Aspire Garments Limited (Extension)

5 December 2023

Fabrics and Accessories Shed is a single storied steel shed.

Observation-1: Design report need to be review against lateral loading

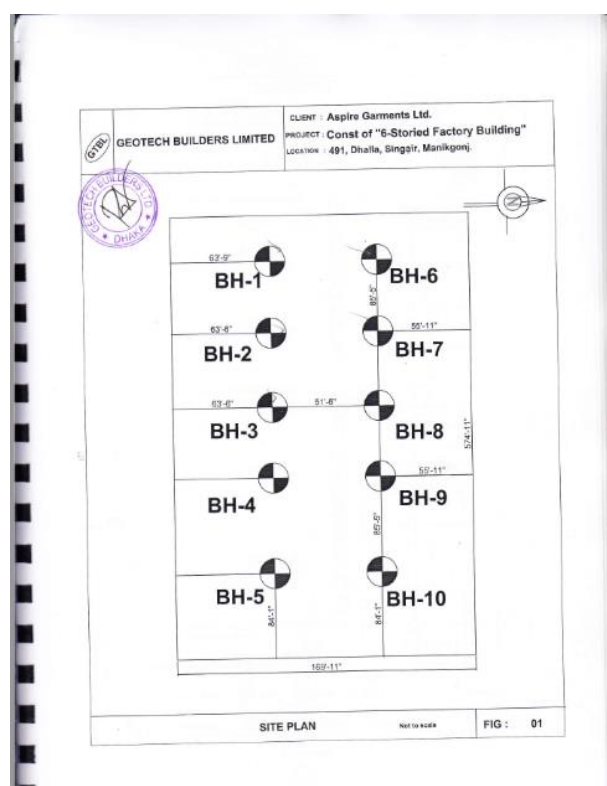
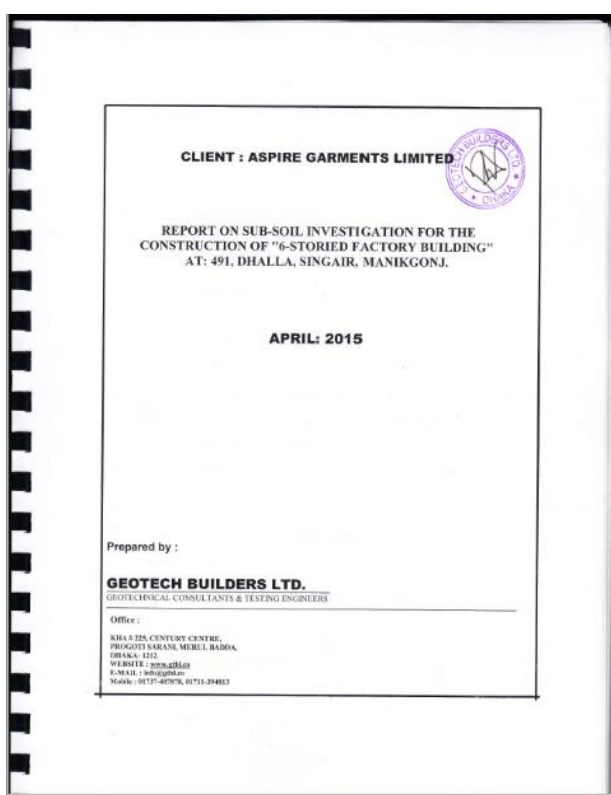
Description: Design report was found available for the structure considered lateral forces for the structural members and connection adequacy. The seismic design category has not been mentioned in the design report. A soil test report for a six storied factory building has been provided. The borehole layout does not represent the Fabrics and Accessories Shed. Additionally, the ultimate bearing capacity of the soil for the footing foundation has been considered 3.81ksf. But no calculation has been provided against the consideration. However, the prepared design documents need to be checked against lateral loads following BNBC 2020 by RSC. Submit the design documents including software-based analysis model to the RSC for detail review.

Observation-2: Improper as-built drawing

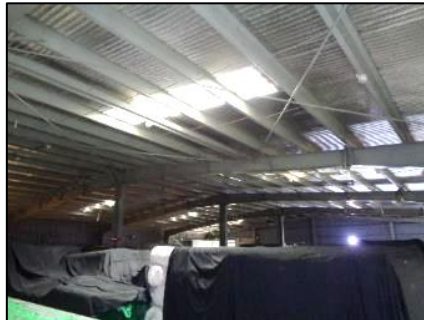
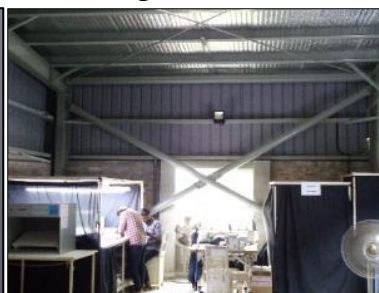
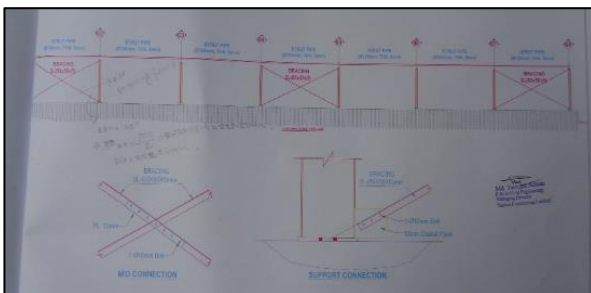
* Regular shape found.

Uniform shape rafter at gable

Vertical Bracing- Steel pipe

Description: During inspection, mismatches were found between onsite condition and provided hard copy of the as-built drawing. The shape of the rafter R3 has been shown tapered in drawing but at site condition, shape of rafter was found uniform shape. The web depth for the R3 rafter was found 310mm. The vertical bracing has been shown double angle 2L-05X50X5mm but at site the vertical bracing was found pipe of 140mm dia. Also, the roof bracing has been shown double angle 2L-05X50X5mm but at site the roof bracing was found 25mm dia re-bar and 25mm dia cable. The layout of the compression strut does not match with the between provided as-built drawing and actual site condition.

The construction drawing is re-presentable with site condition with the few mismatches. Building engineer is required to survey the whole structure and prepare accurate as-built drawing.

Observation-3: Connection gap at several location.

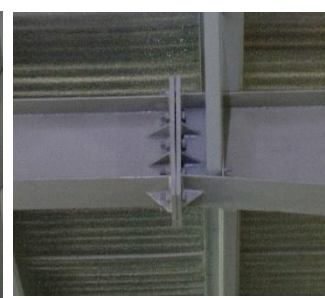
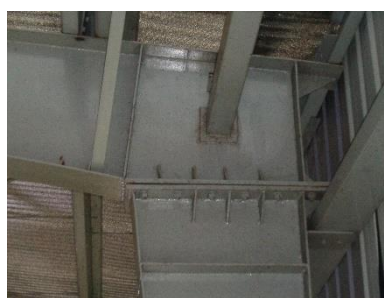
Description: Significant gaps observed at column-rafter and rafter-rafter joints at several location. Factory engineer is required to carry out suitable remedial works.
